UNITED STATES PATENT AND TRADEMARK OFFICE

PPLICATION NO.	FILIN	IG DATE	FIRST NAMED INVENTOR	ATTORNEY DOCKET NO.	CONFIRMATION NO
10/632,058	10/632,058 07/31/2003		Andrew J. Ries	P-11122.00	9970
27581	7590	12/05/2005		EXAMINER	
MEDTRONIC, INC.			•	ALTER, ALYSSA M	
710 MEDTRONIC PARK MINNEAPOLIS, MN 55432-9924				ART UNIT PAPER NUMI	
	,			3762

DETAILED ACTION

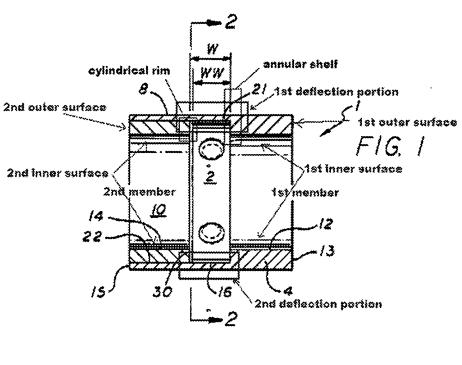
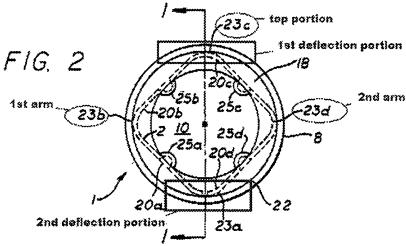
The Applicant argues that Lim does not teach "a first deflection portion extending outward from at least one of the first inner surface and the second inner surface along the top position of the first deflectable clip, and a second deflection portion extending outward from the at least one of the first inner surface and the second inner surface to be positioned between the first arm and the second arm".

However, the examiner has included figure 1 and figure 2 to more clearly depict that Lim does in fact teach a first deflection portion extending outward from at least one of the first inner surface and the second inner surface along the top position of the first deflectable clip, and a second deflection portion extending outward from the at least one

of the first inner surface and the second inner surface to be positioned between the first arm and the second arm, in combination with all other elements of the claims.
